SHA CTP Project No. MO344M21, MD 355, Phase 2, Montrose Parkway, Design Review

Description

Figure 4: Alternative 1: Randolph Road Closed

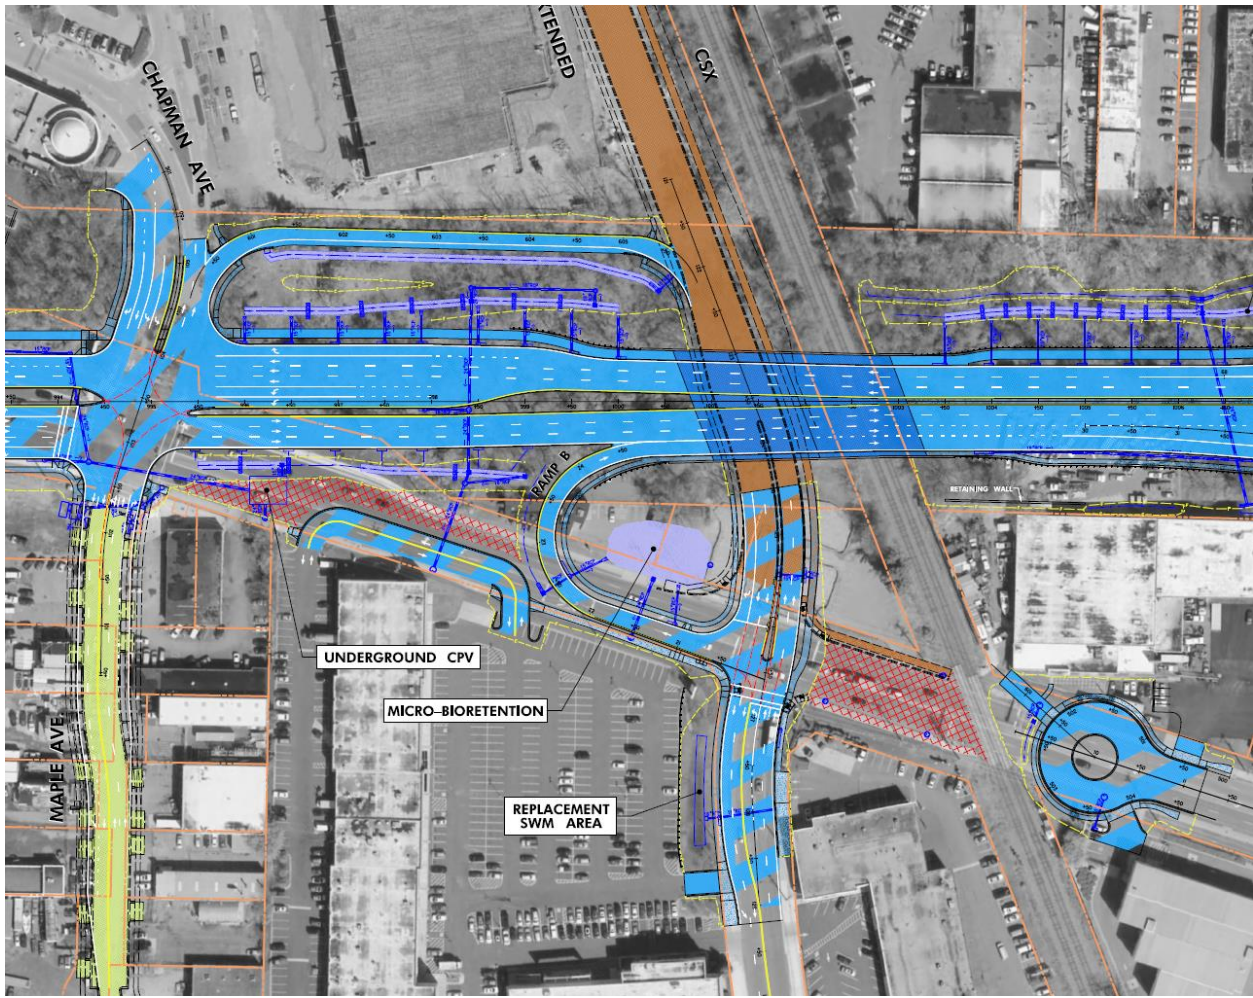
SHA recommends Alternative 1 because it is listed as having a high accident probability based on the Federal Railroad Administration's (FRA) Accident Prediction Report for Public at-Grade Highway-Rail Crossing at this location. Twenty (21) collisions in total, between a rail vehicle and a roadway user, have been reported to FRA in the past 35 years. Of these two (2) have involved pedestrians, three (3) have resulted in fatalities and five (5) have resulted in injuries. The FRA's Accident Prediction System currently ranks the CSX railroad crossing at Randolph Road as the fourth most accident prone crossing of the nearly 700 crossings in the State of Maryland as of December 31, 2011. Refer to Attachment 5 for FRA's top ranked crossings.

Figure 6: Montrose Parkway, Chapman Avenue/Maple Avenue Intersection

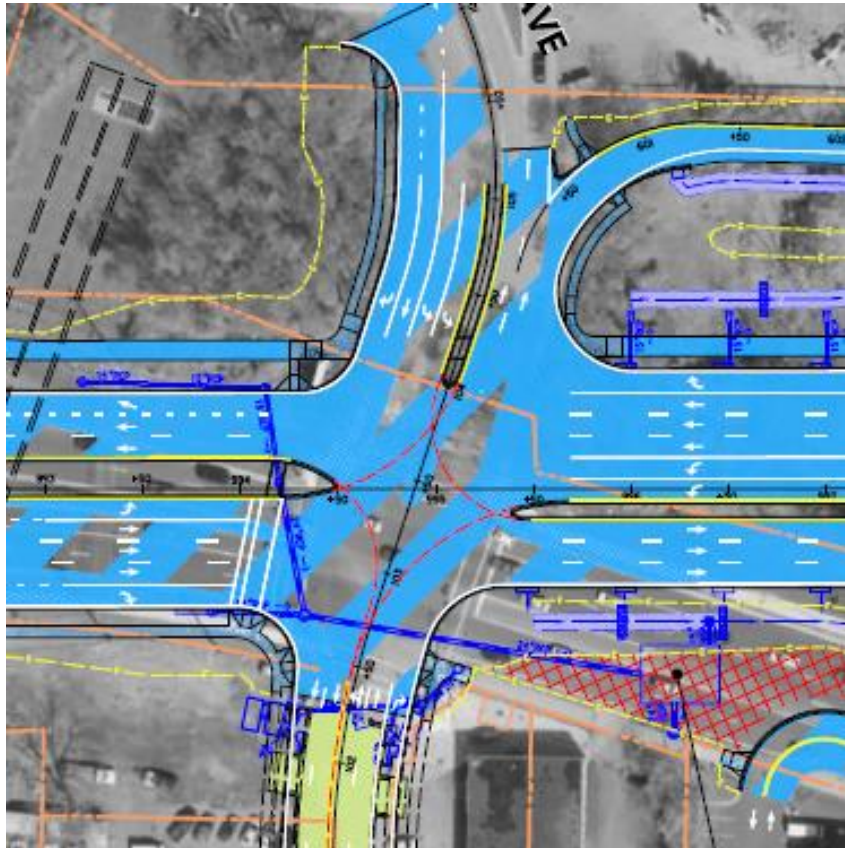
With the closure and removal of the Randolph Road segment between Maple Avenue/Chapman Avenue and Nebel Street, this intersection provides the necessary access to the existing and future land uses to the north and south of Montrose Parkway with the design remaining as shown in the alternatives above, with up to nine (9) east-west lanes and six (6) north-south lanes. Figure 6 below shows the proposed intersection design.

If Randolph Road remains open and with other adjustments to turn lane lengths at this intersection, reducing the number and length of lanes there should be seriously considered. A narrower roadway with fewer lanes would be a more compatible pedestrian-friendly, transit-oriented environment while providing the minimum necessary lanes to maintain acceptable levels of congestion. The desirable lane configuration for each approach at this intersection could be reduced to:

Figure 7: Proposed Modifications to Chapman Avenue-Nebel Street Connection

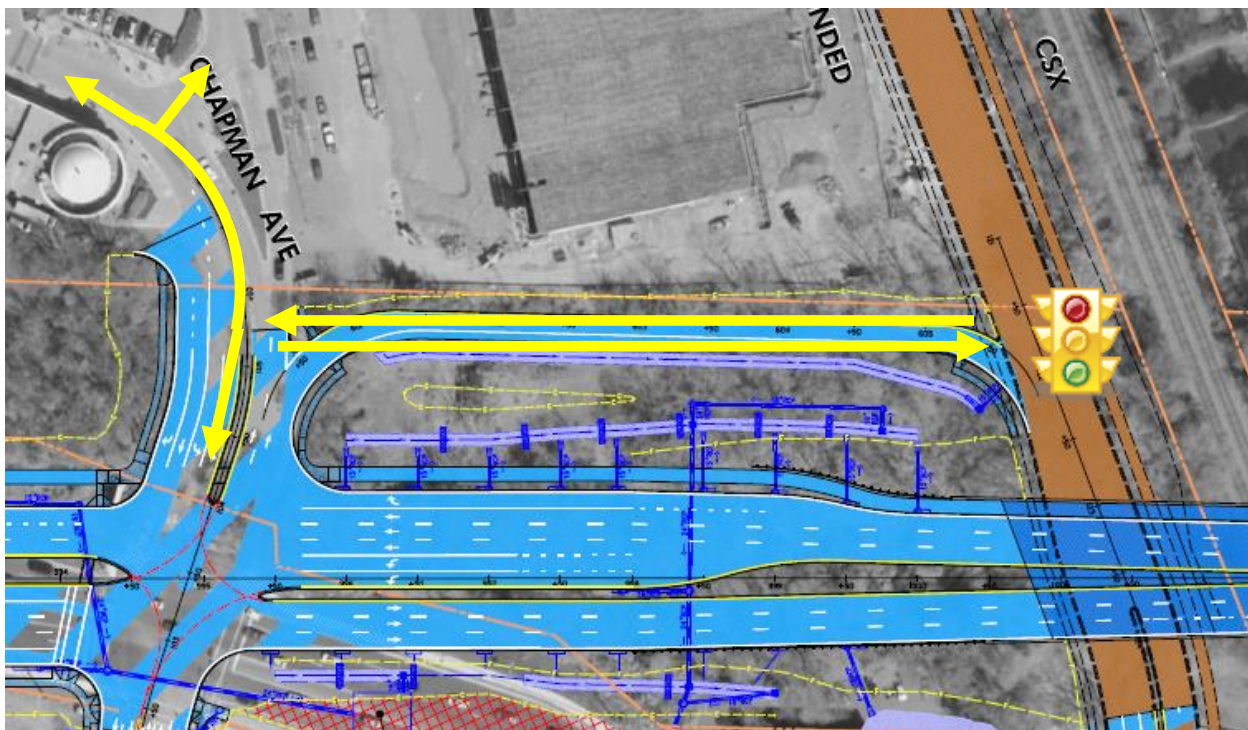
The current plans (both alternatives) propose a one-way eastbound connection from Chapman Avenue to Nebel Street to the north of Montrose Parkway. This connection would function as a partial jug handle to provide limited access from eastbound and westbound Montrose Parkway and northbound Maple Avenue to southbound Nebel Street only. With the removal of the Randolph Road segment between Maple Avenue/Chapman Avenue and Nebel Street, motorists traveling on southbound Chapman Avenue cannot access Nebel Street and those traveling on Nebel Street cannot access Chapman Avenue. The only connection between these roads is recommended in the White Flint Sector Plan as a future “local street” on the south side of the Montrose Shopping Center (south of the Montrose Parkway).

The Planning Department staff recommends changing this one-way eastbound connection to a two-way connection. The two-way connection would provide access for all movements between Maple Avenue/Chapman Avenue and Nebel Street, with adjustments to Chapman Avenue, itself, and a full-movement intersection at Nebel Street and the connecting roadway. The parallel connection would function more like a street grid with better interconnectivity than a freeway ramp. A reduction in the number of lanes at the Chapman Avenue/Montrose Parkway intersection would help provide a greater separation of this two-way connection from Montrose Parkway and make turning movements safer. Figure 7 shows the staff recommended change in yellow.

Figure 8: Proposed Modifications Continuing Randolph Road to the West of Nebel Street

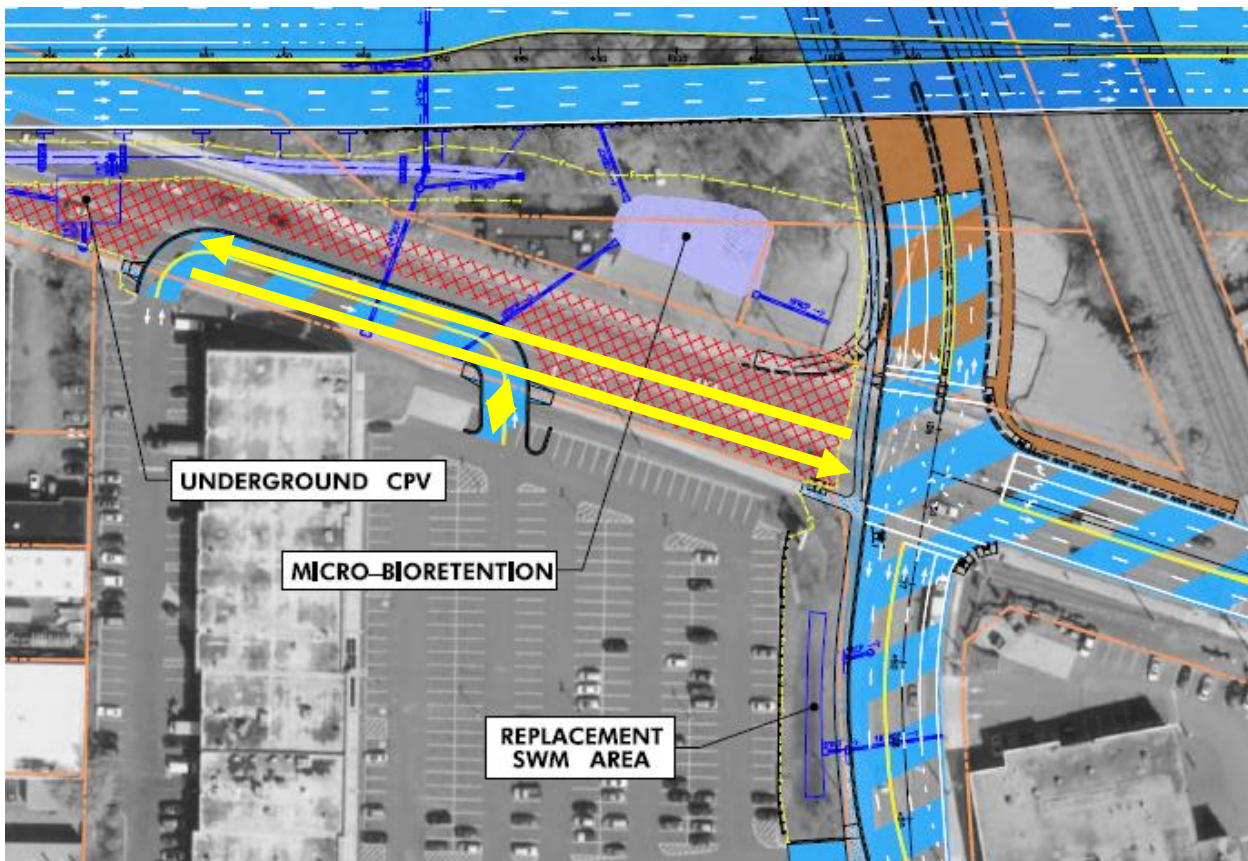
The current plans propose replacing the Randolph Road segment between Maple Avenue/Chapman Avenue and Nebel Street with a driveway connection between the existing east and west parking areas within the Montrose Shopping Center. The Planning Department staff view this driveway connection as a short-term access solution until the White Flint Sector Plan’s “local street” is built. But, if Randolph Road remains open, a more useful connection could be created from the intersection of Randolph Road with Nebel Street and allow access for the Shopping Center’s parking area. Figure 8 shows the staff recommended change in yellow.

Figure 9: Parklawn Drive-Montrose Parkway Interchange

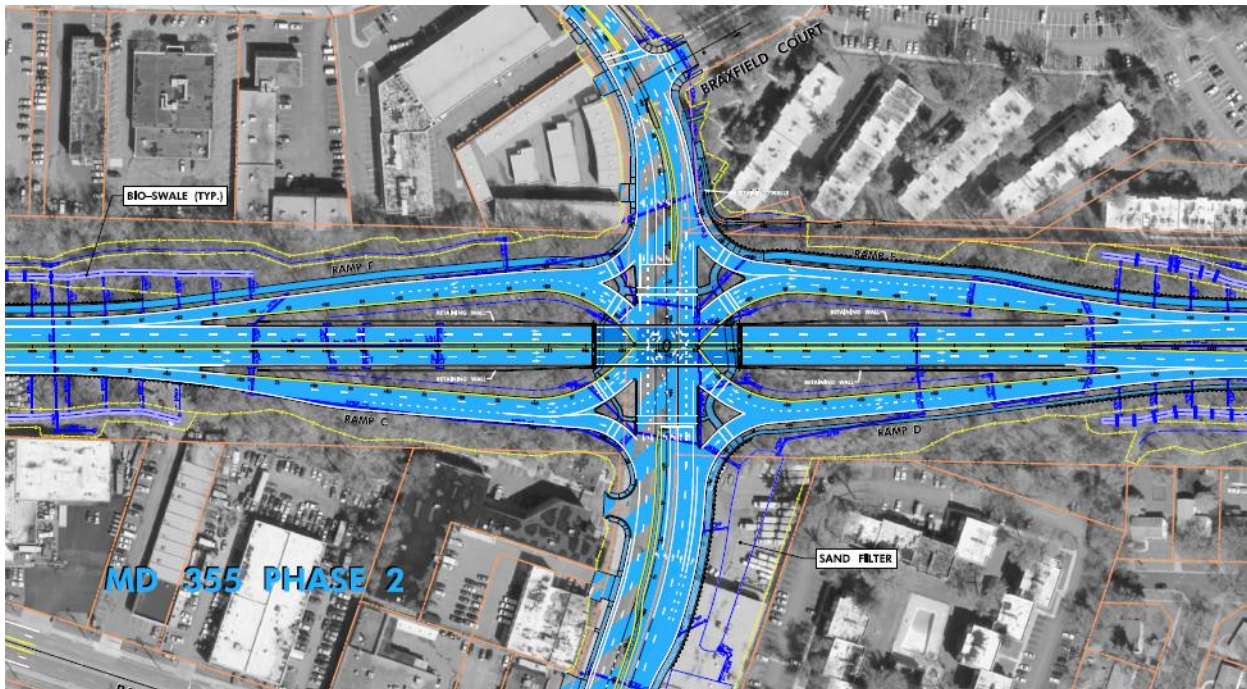
The 2009 Twinbrook Sector Plan reflects an interchange at this location, although this area is outside of the Sector Plan boundary. To promote smart growth, walkable, transit-oriented communities, the interchange will be reconsidered in our upcoming White Flint II Sector Plan. At this time, Planning Department staff believes that an at-grade Montrose Parkway/Parklawn Drive intersection, in place of the current interchange design, may further the smart growth principles we are proposing in our sector plans. As shown on Figure 9, a Montrose Parkway/Parklawn Drive interchange would create more of a barrier between the Twinbrook communities and the White Flint II communities. Alternatively, an at-grade intersection would support the current planning practice of reducing vehicular barriers by improving pedestrian and bicyclist-friendly connections, a goal of the upcoming White Flint II Sector Plan.

If an at-grade intersection at Montrose Parkway and Parklawn Drive is feasible, our current effort on the White Flint II Sector Plan could include a recommendation to provide the at-grade connection rather than an interchange and look at alternative means to reduce congestion and vehicle trips. It seems appropriate to analyze these various projects in the larger context of the upcoming Sector Plan effort if initial studies show they are at least feasible.

We recommend that the Planning Board ask MCDOT and SHA to provide an analysis that compares the traffic operations of an at-grade intersection to the current interchange design and to provide a preliminary design of an at-grade intersection for review in advance of or in conjunction with the Mandatory Referral submission of this project.
